February 2, 2026

ADDENDUM NO. 2

Autauga WMA Office Meeting Complex  
Prattville, Alabama

Item No. 6: Refer to Plans, Sheet P1.1 and P3.1, 35 of 46 and 37 of 46, Plumbing Non-Pressure Plan and Plumbing Isometrics:

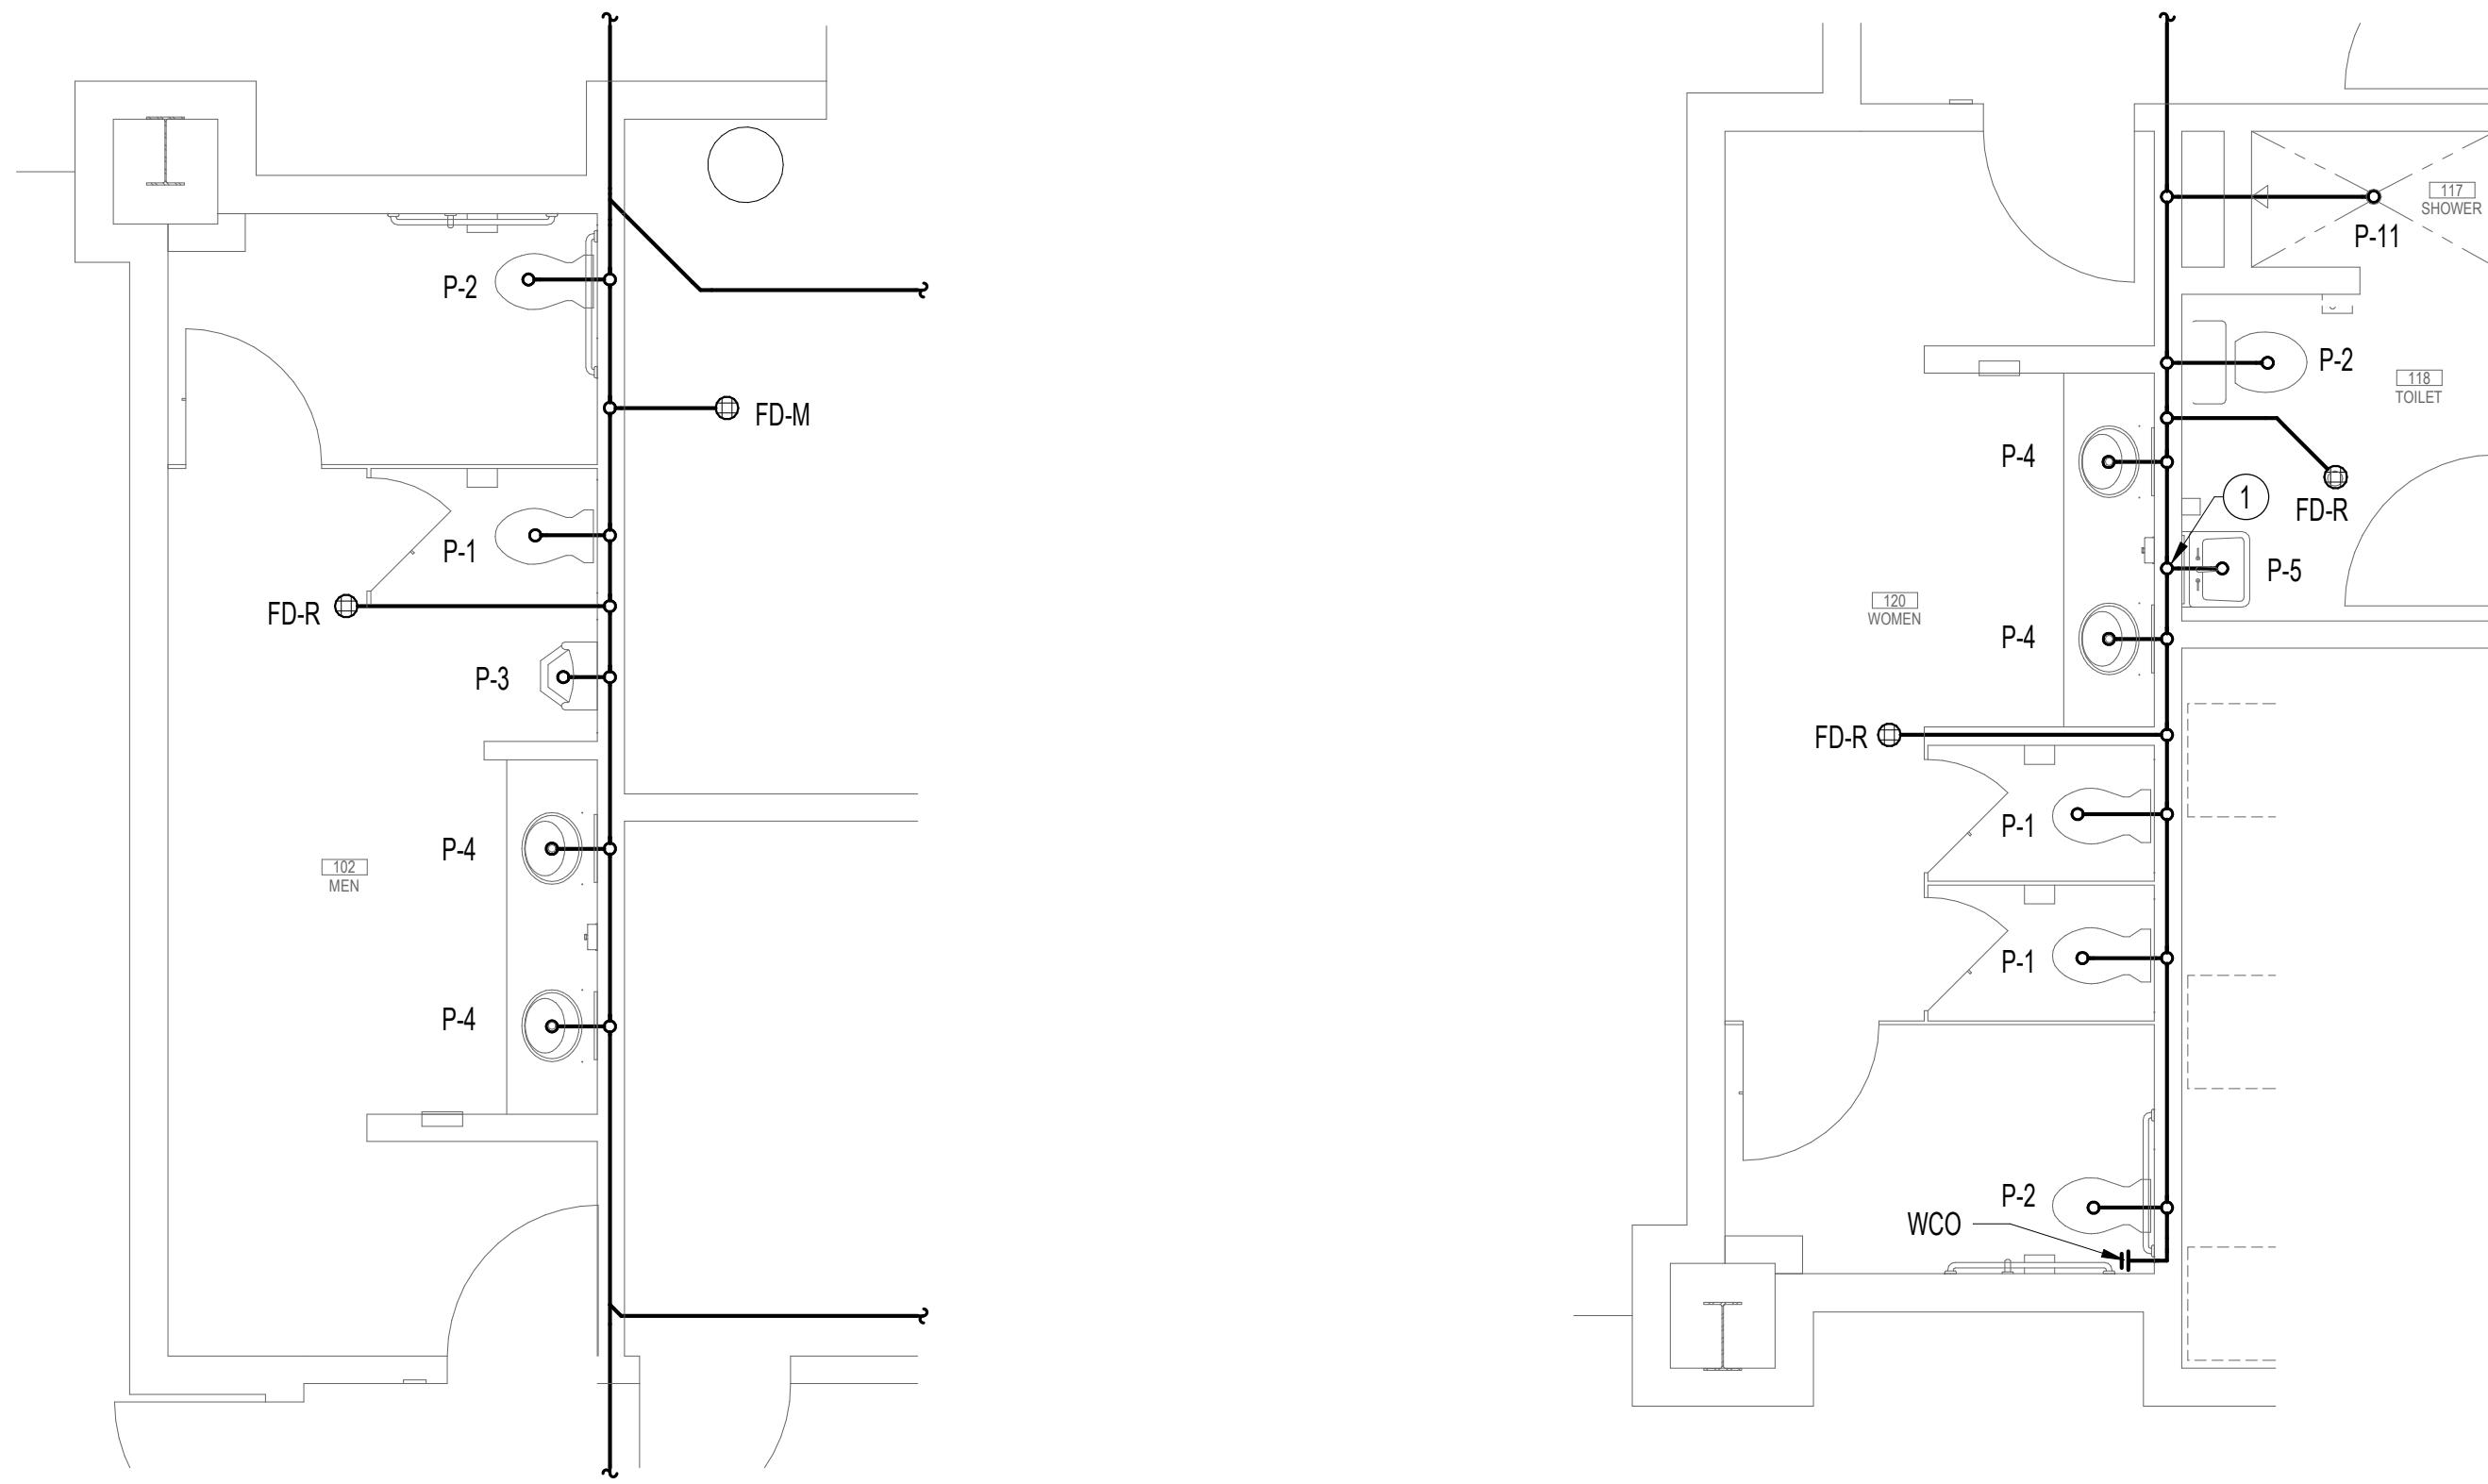
A. See attached Revised plumbing sheets P1.1 and P3.1 for revised 4" drain line.
